Suzuki Across - hybrid system warning message

Data sheet	
Manufacturer	Suzuki
Vehicle model	Across
Engine	All models with hybrid drive
Year of manufacture	2020
Symptoms	Hybrid system warning message

Warning message "Hybrid system error" with error code P1CCC

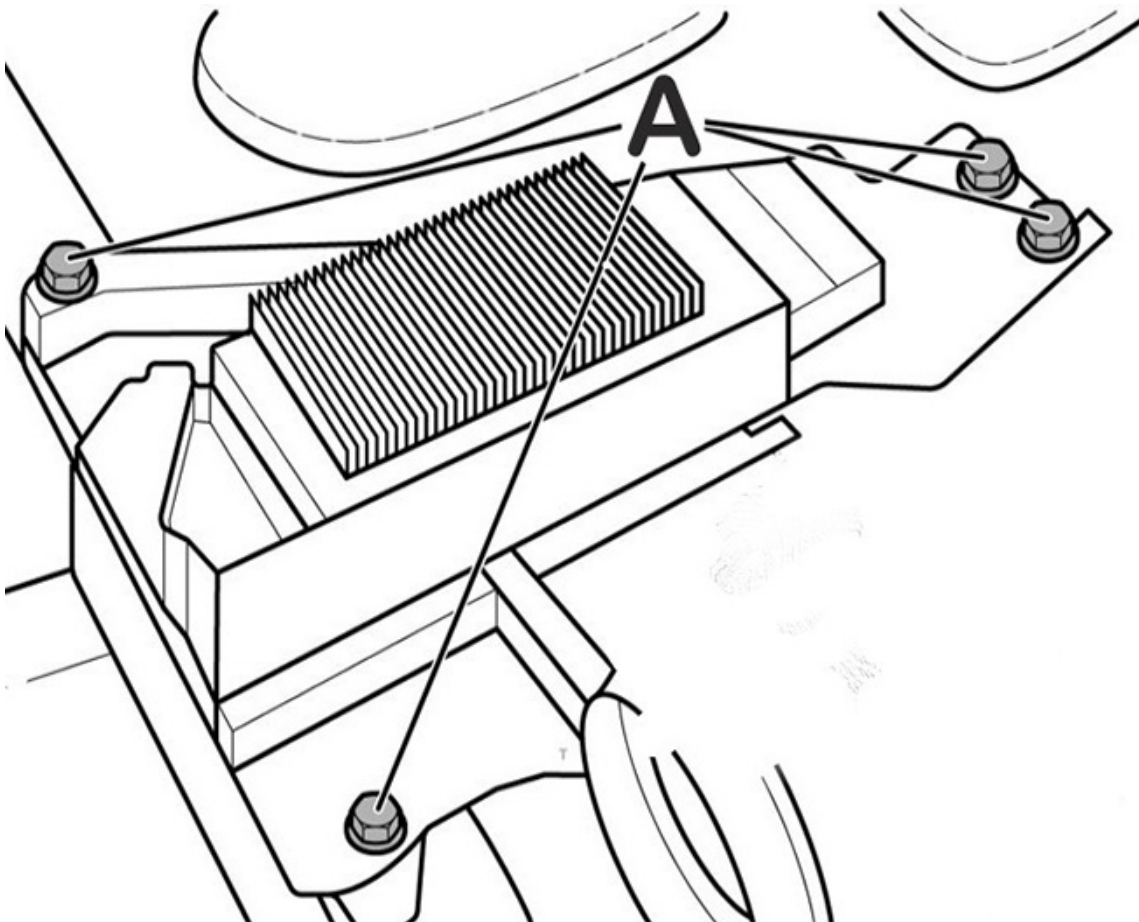
With the vehicle mentioned above, it can happen that a warning message is issued in connection with the hybrid system. The error message appears in the instrument cluster: "Fault in the vehicle electrical system, voltage converter". The system prompts the driver to bring the vehicle to a standstill. The code P1CCC is then often stored in the error memory (faulty ground connection).

This may be caused by unsuitable fastening screws on the DC/DC converter. These lead to high contact resistances with the corresponding error messages being sent.

In order to remedy this, the 4 screws (A) should be replaced with a modified variant (T9011-908C9-200).

Make sure the screws are firmly seated and that there are no signs of corrosion.
